# Team Update 21

## Game & Season Manual

Figure 10-5 FIRST in Michigan District Championship Playoff Bracket

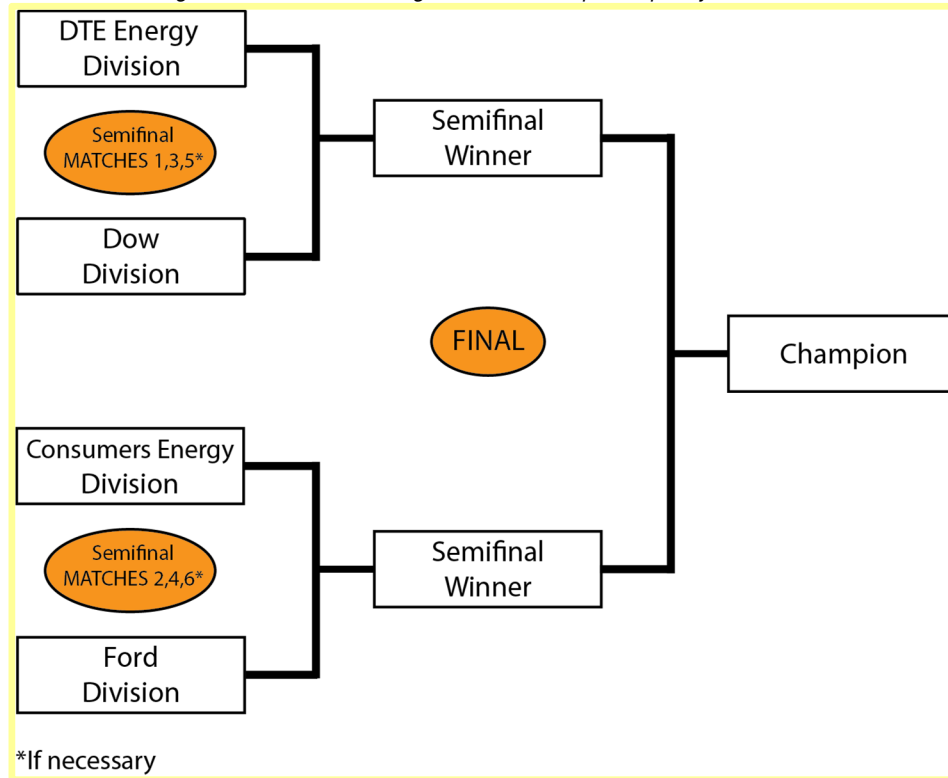
### Section 10.12.3.9 District Championships with Multiple Divisions

Some District Championships will have multiple divisions. In these cases:

- Division winning ALLIANCES play each other in District Championship Playoffs, employing the bracket below that corresponds to their District, until a winning ALLIANCE for the event is determined.

*Figure 3-17 Temporary SCALE lighting.*

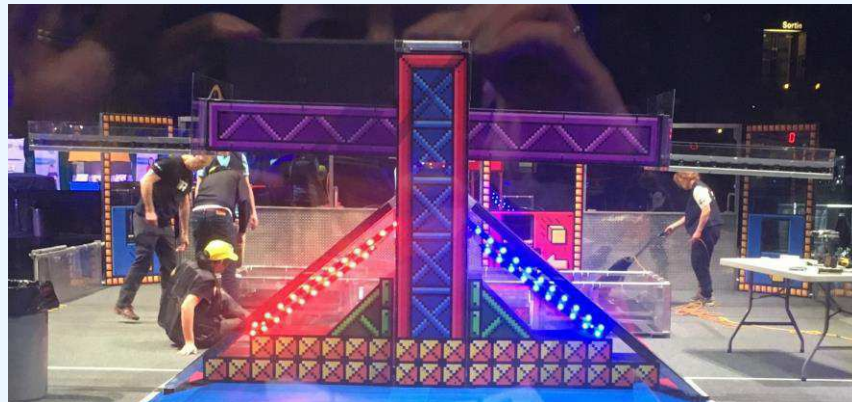
Until further notice, events are instructed to install the SCALE light strings in the cavity below the outriggers instead of around the PLATES, approximately as shown below.

Figure 3-19: Blue ALLIANCE VAULT

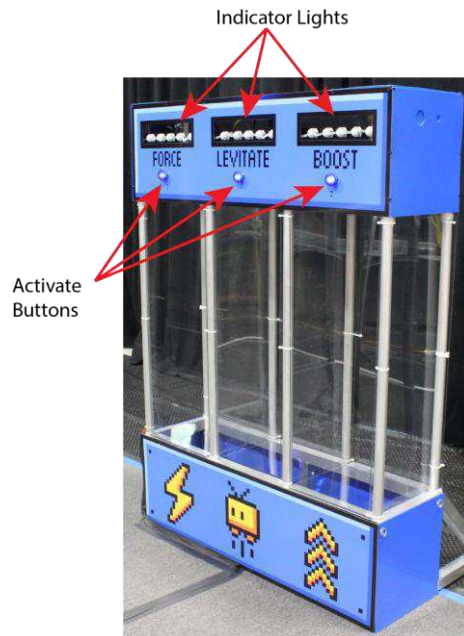
POWER CUBES placed logo-side-up may result in POWER CUBES not being sensed consistently by the FIELD.

Caution, there may be orientations where all three (3) POWER CUBES will not fit in a VAULT column, but if HUMAN PLAYERS place POWER CUBES logo side up **down** they'll fit with room to spare.

Figure 8-8: BUMPER support examples

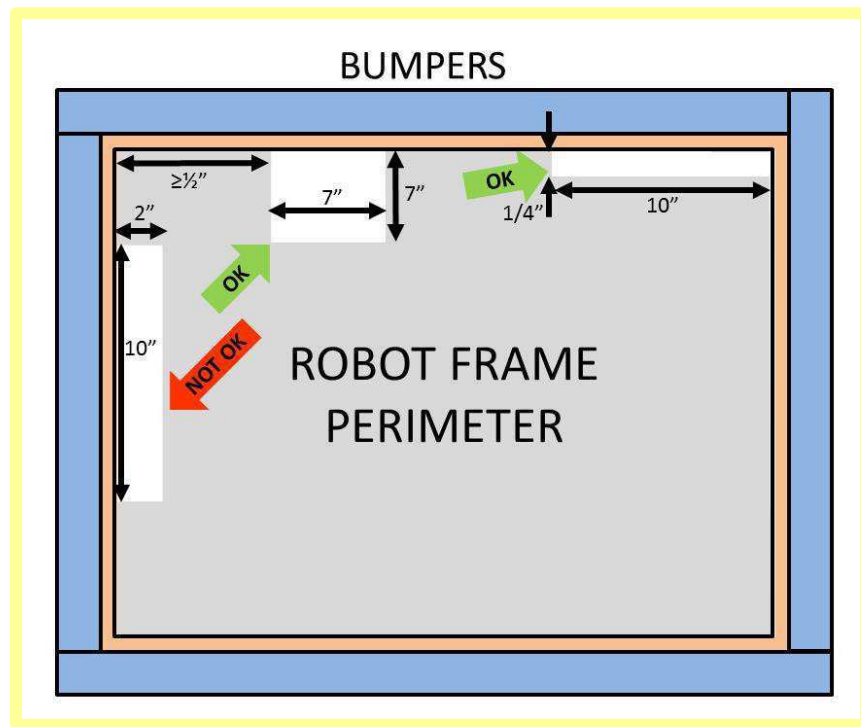
**R32.** BUMPERS must be supported by the structure/frame of the ROBOT (see Figure 8.8). To be considered supported, a minimum of ½ in. (~12.7 mm) at each end of each BUMPER wood segment must be backed by the FRAME PERIMETER ( $\leq \frac{1}{4}$  in. gap). “Ends” exclude hard BUMPER parts which extend past the FRAME PERIMETER permitted by R30, part B. Additionally, any gap between the backing material and the frame:

- A. must not be greater than ¼ in. (~6 mm) deep, or
- B. not more than 8 in. (~20 cm) wide

Example 1: A ROBOT may not hold the SCALE PLATE in a “balanced” state.

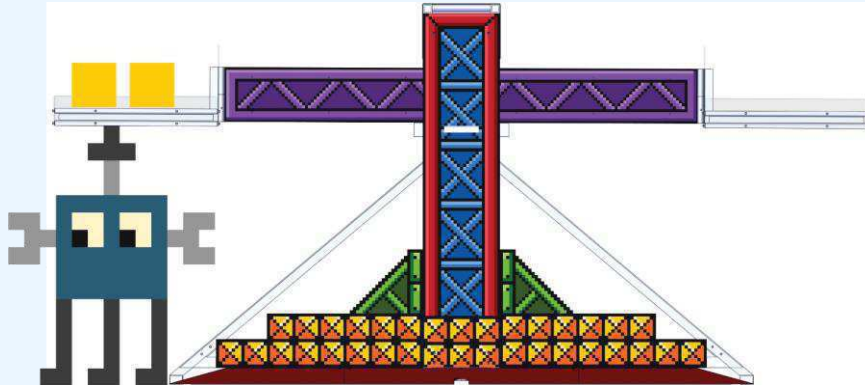
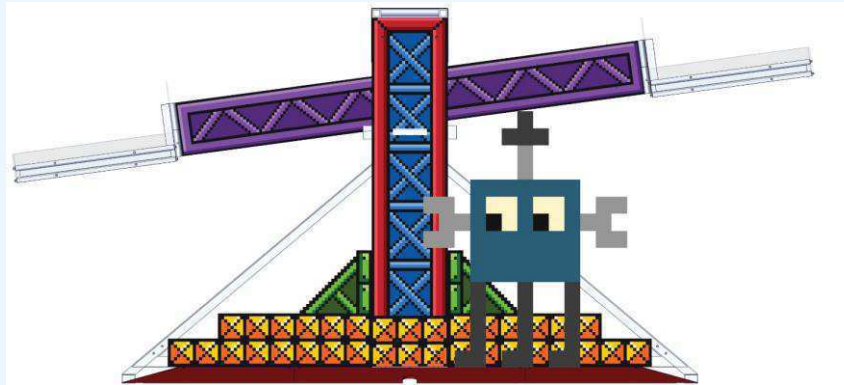
The “momentary” and “minimal” language in G25 is subjective but necessary because ROBOTS may cause PLATE movement (or prevent PLATE movement) as they place POWER CUBES and bump PLATES, get hit, etc.

Generally, “momentary” means near instantaneous, or in other words, contact for less than approximately one (1) second and “minimal” means a displacement of fewer than approximately three (3) in. However, REFEREES are not expected to measure, and be accountable to, real-time PLATE displacement or precise timing from their vantage points.

Figure 3-14: SWITCH PLATE dimensions

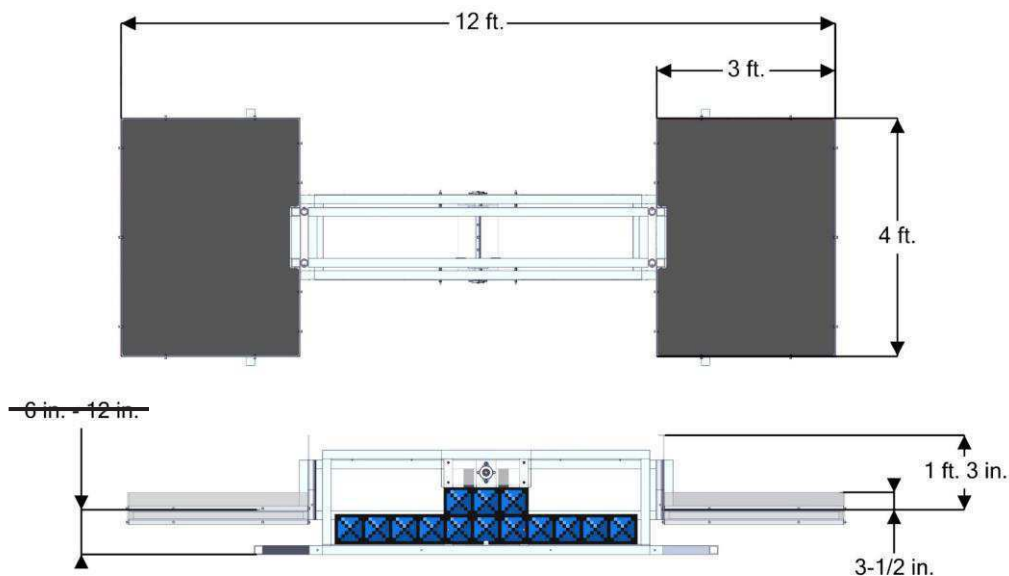
Figure 3-14 has been updated to remove the lower left dimension, which doesn't add value.
